**HAMMOND HIGH SCHOOL
RENOVATION AND ADDITION**

ADDENDUM NO. 8

DATE: August 5, 2020

PROJECT: Hammond High School Renovation and Addition
Columbia, Maryland
Architect Project No. 18011

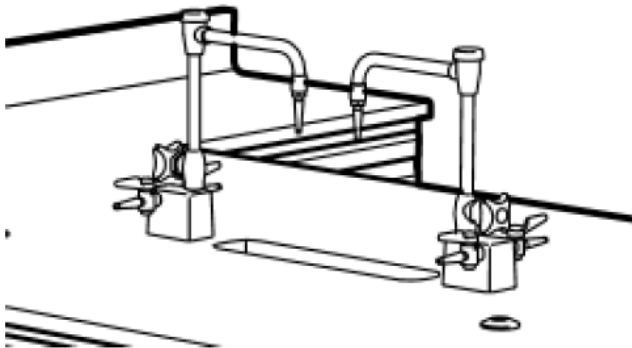
134. At the Science laboratory casework assemblies (example S-08/A9.11) there are identifiers noted at the bottom of each assembly section. Bolded text appears to identify if exhaust, gas, water, and or electric are to be utilized. S-08 has gas, water and electric bolded. The graphic detail shows a standard vacuum breaker mixing valve faucet and no other type of fixtures. Please confirm if the faucet is to be a combination faucet. See detail below

RESPONSE: Either a combination faucet or separate gas turrets will be acceptable.
